Our Ref: MG1002/SRA/01

**Re: Cross Leys Quarry – Stability Risk Assessment AEGB Liner Permeability Sensitivity Analysis**

Figure 1 - Sensitivity Analysis for Selected Construction Lifts with the Reported Factors of Safety

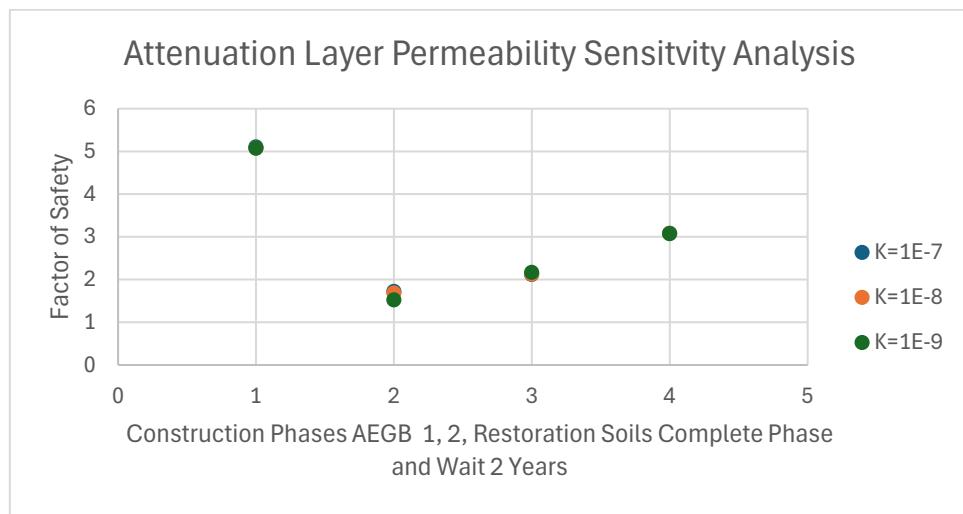
As requested in the permit application for Cross Leys Quarry a sensitivity analysis has been undertaken on the Plaxis modelling to assess how sensitive the modelling is to changes in permeability of the attenuation layer. As part of the sensitivity analysis a range of permeabilities were assessed for the attenuation layer. The selected permeabilities were  $K=1E-7\text{m/s}$  (minimum specification requirement),  $K=1E-8\text{m/s}$  (original modelled value) and  $K=1E-9\text{m/s}$ . The Plaxis models have been rerun and the factors of safety have been reported for the different permeabilities assessed (for each of the lining construction phases and the overall final stability). The sensitivity analysis results are presented in Appendix 1 of this letter.

Figure 1 above, for the attenuation layer construction phases (1 and 2), shows that as to be expected there is a slight decrease in the factors of safety reported when the permeability is lowered, with the highest factors of safety reported when the permeability of the attenuation layer is  $K=1E-7\text{m/s}$ . Figure 1 shows that the models are not particularly sensitive to changes in permeability with only marginal changes noted with a fairly close grouping.

It is likely that given the incoming material, the permeability for the attenuation layer will be lower than  $K=1E-7\text{m/s}$  (specification requirement) but it is likely to have fine drainage pathways in the material which will aid pore water dissipation and likely result in a macro-permeability of  $K=1E-8\text{m/s}$  which is the value used in the original SRA report.
